SUBJECT: NORTH ANNA POWER STATION, UNITS 1 AND 2 RE: INSERVICE TESTING PROGRAM FOR PUMP AND VALVES, THIRD TEN YEAR INTERVAL UPDATE (TAC NOS. MB2221 AND MB2222)

SAFETY EVALUATION BY THE OFFICE OF NUCLEAR REACTOR REGULATION  
RELATED TO THE THIRD 10-YEAR INTERVAL INSERVICE TESTING PROGRAM

NORTH ANNA POWER STATION, UNITS 1 AND 2

Figure No. P-6.1

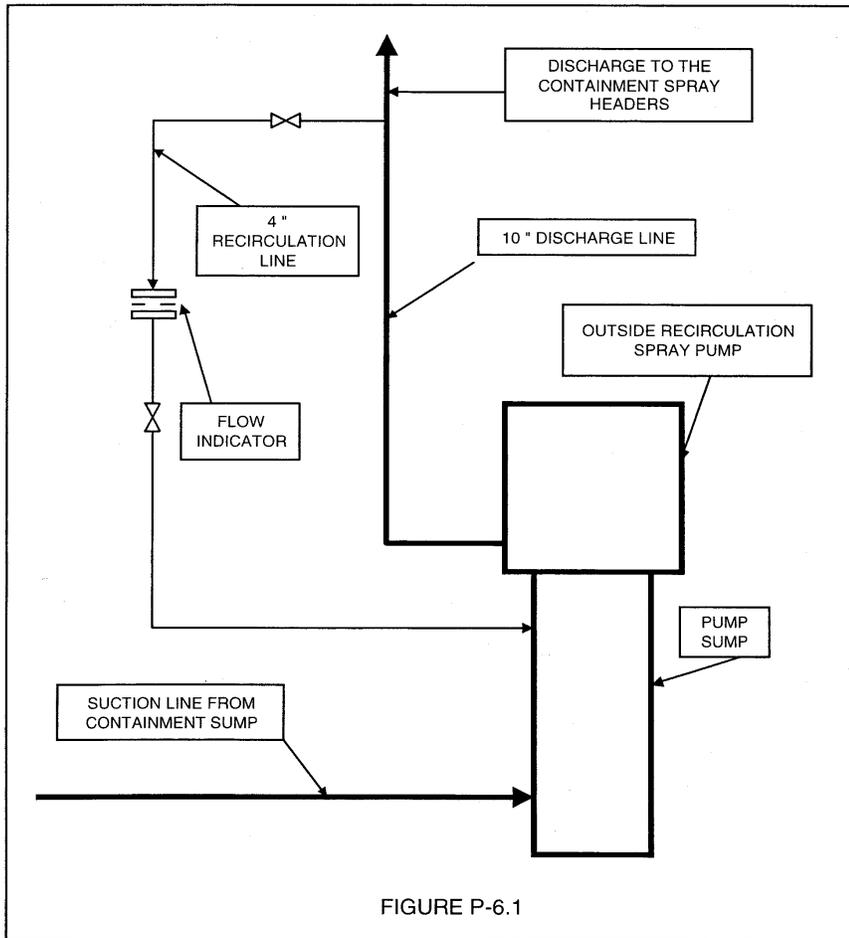
The test loop for the outside recirculation pumps consists of a 10" pump discharge line feeding into a 4" recirculation line which feeds back to the pump sump. Refer to Figure P-6.1. With test loop, pump design flow cannot be established. Also, the discharge piping was not designed to be temporarily reconfigured so that pump design flow could be achieved.

As an alternative to flow testing at the design flow rate, the test loop shown in Figure P-6.1 will be used. Reference flows are typically established with test loop in the range of 1450 to 1500 gpm, whereas the pump design flow is 3640 gpm. The low reference flows result from restrictions due to the small 4" recirculation line and the limited volume of water in the test loop. The limited water volume results in a rapid temperature rise in the test loop due to heat loads added by the running pump. This temperature rise affects repeatability of the measured hydraulic parameters. Therefore, care must be taken to ensure that the pump run time is limited and that the flow rate is maintained within an optimal range.

As an alternative to the flow testing at design flow rate, the licensee has proposed testing with a test loop shown in Figure P-6.1. The test loop is a 4-inch recirculation line. The reference flows established with this test loop are in the range of 1450 to 1500 gpm whereas the pump design flow is 3640 gpm. The low reference flows are limited due to size of 4-inch recirculation line. The limited water volume and the heat loads added by the running pump will rapidly raise the temperature of the water in the test loop. The testing will be performed in a manner to ensure that the pump run time is limited and the flow is maintained within an optimal range. The highest flow that can be measured while maintaining stable test conditions is approximately 40 percent of design flow. Measuring more than one point on the pump curve is limited to flow rates less than the 1450 to 1500 gpm range. Throttling the flow down to 20 percent of design flow to measure another point on the curve may cause flashing across the throttle valve producing hydraulic instabilities and less-than-meaningful results. In the 1450 to 1500 gpm range of the head curve for these pumps, the head curve is not flat but well sloped. (See Figure P-6.2 for Units 1 and 2). As shown in the Figure P-6.2, the test point falls on the nominal vendor curve. Any deviation from the nominal curve will show degradation of the pump.

gure No. P-6.2 (UNIT-1)

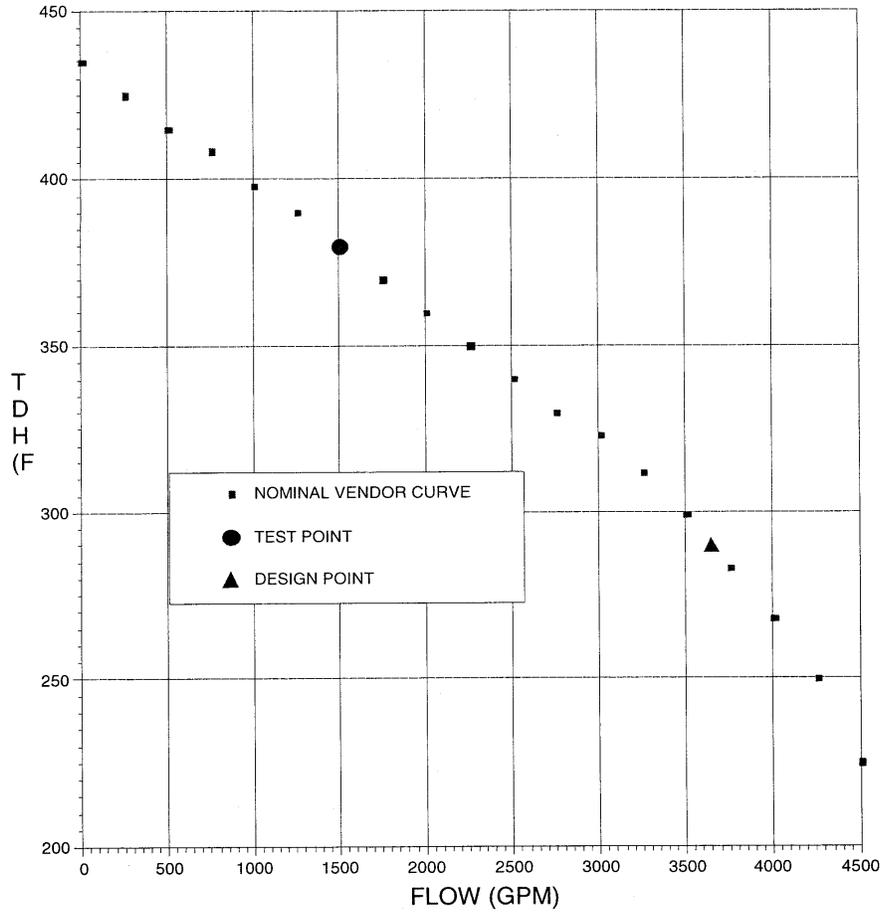
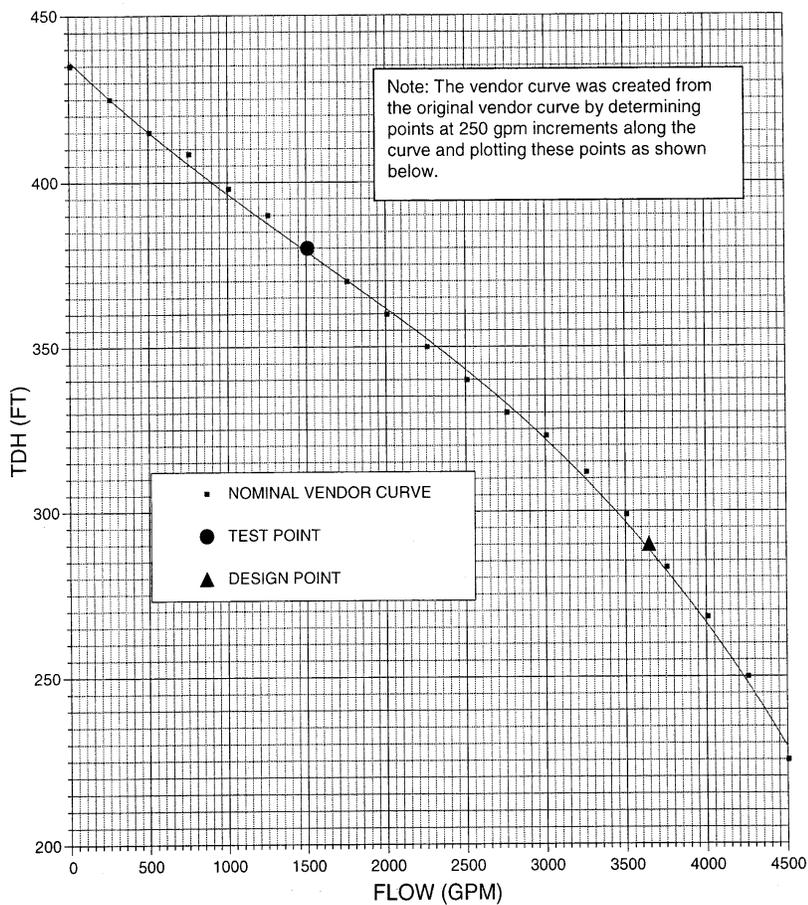
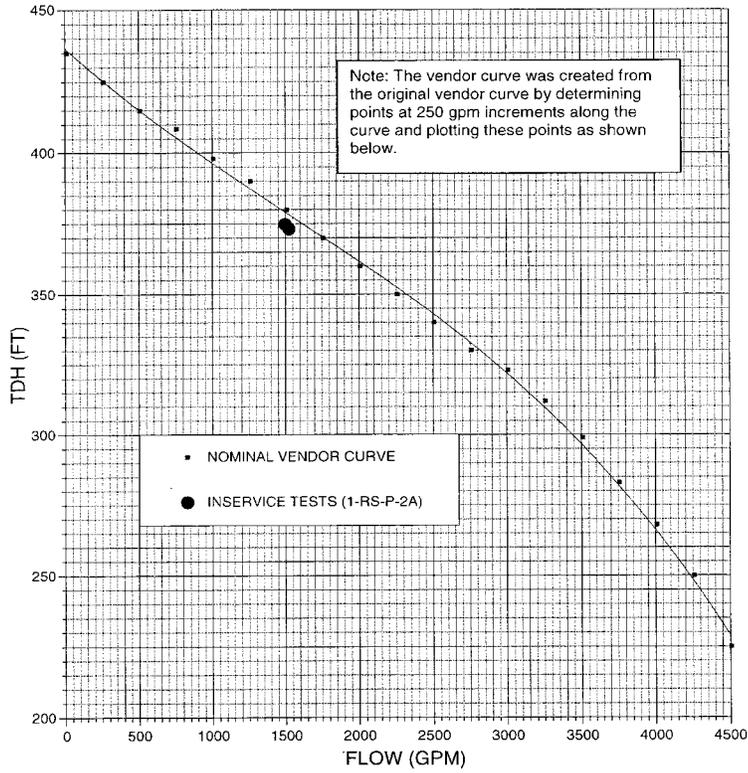
In the 1450 to 1500 gpm range of the head curve for these pumps, the head curve is not flat, but well sloped. Refer to Figure P-6.2. Therefore, as performance degrades due to internal recirculation caused by increasing internal pump clearances, the differential pressure will measurably decrease for a given reference flow rate. As discussed above, testing the outside recirculation spray pumps over the full range of the pump curve and measuring at least five points along the curve is impractical.

As an alternative to testing within 20% of the design flow, the reference values will be established at approximately 40% of the design flow. It is our understanding that testing at design flow is important for pumps with characteristic head-flow curves that are flat or gently sloping in the low flow region (little change in developed head with increasing flow). In the low flow region, increasing internal flows, usually due to wear, are difficult if not possible to detect. Pumps with the "flat" curves at low flows should be tested at near design conditions to determine if increasing internal recirculation flows have degraded pump performance to the point where design requirements cannot be met. This situation does not apply to the outside recirculation pumps if they are tested at 40% of design flow. Testing at the reference flows will detect pump degradation because the pump curve is well sloped at the point of testing. Refer to Figure P-6.2. [for Units 1 and 2]

From Figure P-6.2, the nominal vendor curves, the shutoff head of pumps is 435 feet. As discussed above, the pump can only be tested on a recirculation flow path which is sized for approximately 40 percent (1500 gpm) of the design flow of 3640 gpm. In case of Seabrook Station, Unit 1 (Reference 5), the shutoff head is 700 ft. The pump can be tested on recirculation flow path which is sized for approximately 68 percent (1900 gpm) of the required design flow of 2808 gpm. The flow and TDH values from the head-flow curves for North Anna Station and Seabrook Station (Reference 5) are shown in the following table for comparisons:

The licensee provided curves (Figure P-6.2 ) showing flow rate versus the corresponding TDH. The intent of the curve is to provide trend data on the TDH at each measured flow rate for the outside recirculation pumps. The expected result is that at higher flow rates, there is a lower pump TDH. This provides an indication that the pumps were tested in an area of the curve where the intent of the comprehensive test would be satisfied.

Figure No. P-6.3

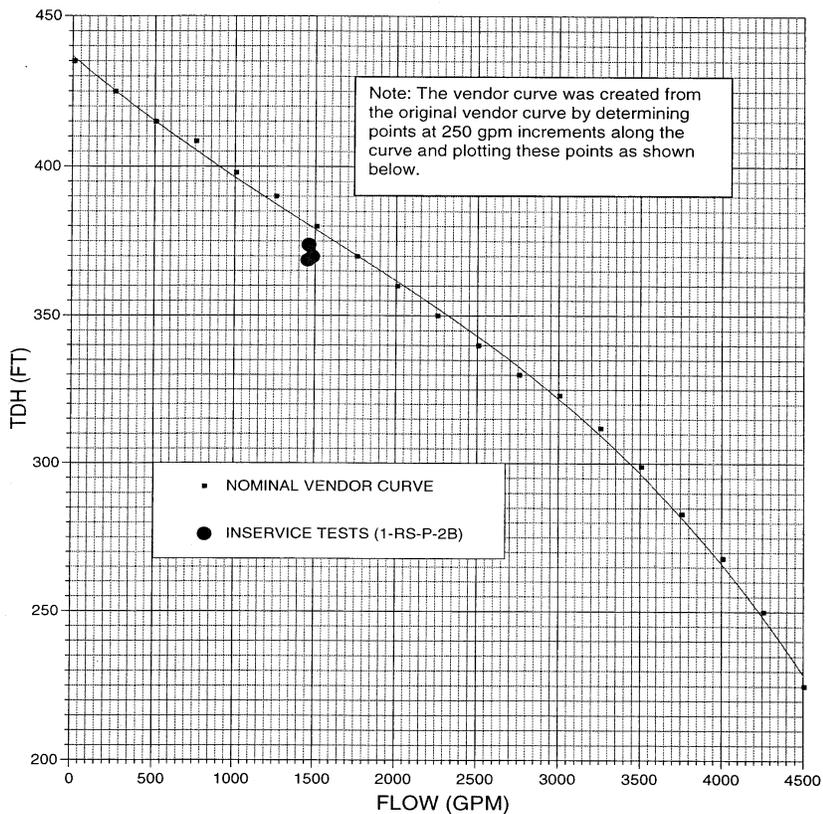
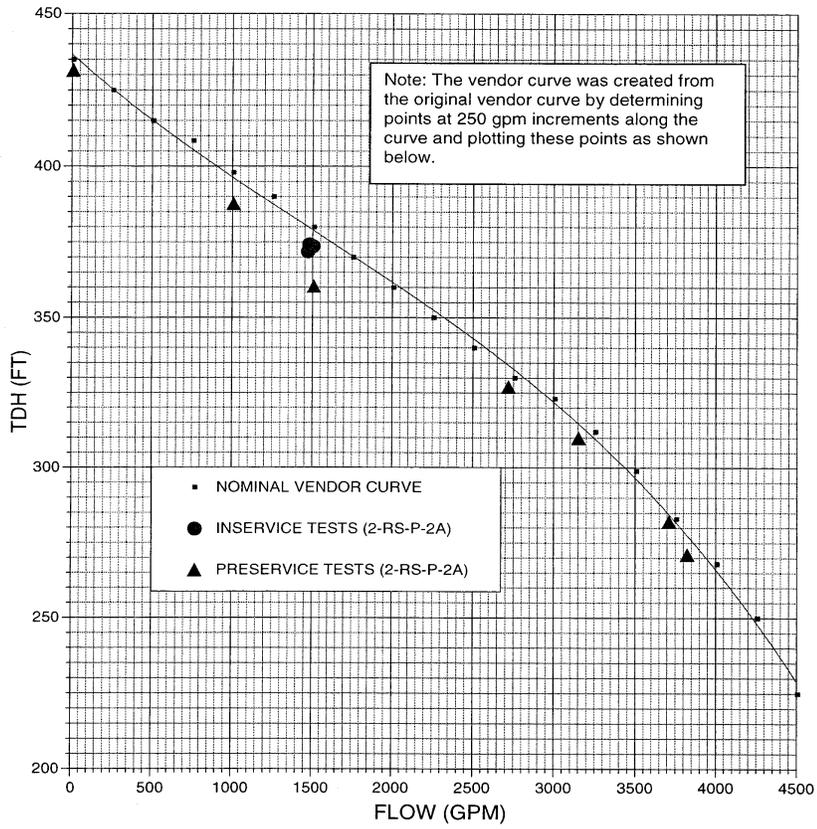
The licensee provided pump curves for Units 1 and 2. Figures P-6.3 and P-6.4 are for Unit 1 outside recirculating spray pumps 1-RS-P-2A and 2B. The curves in these figures show nominal vendor curves with inservice test points. For Unit 2 pumps 2-RS-P-2A and B, the curves in Figures P-6.5 and P-6.6 show not only inservice test points but preservice test points. The reason is that the licensee performed preservice tests for Unit 2 pumps only due to hardship as explained by the licensee in the Section 3.6.2 above. The Unit 2 pump curves shows that the slopes of the nominal vendor curves and the preservice test are very close. The slopes of the Unit 1 pump pretest curves would presumably have resembled the slopes of the Unit 2 pump preservice tests, because the Units 1 and 2 pumps are similar. Therefore,

measuring one point at approximately 40 percent of the pump design flow as an alternative to measuring at least five points for the preservice test will provide more meaningful results to ensure operational readiness of the pump.
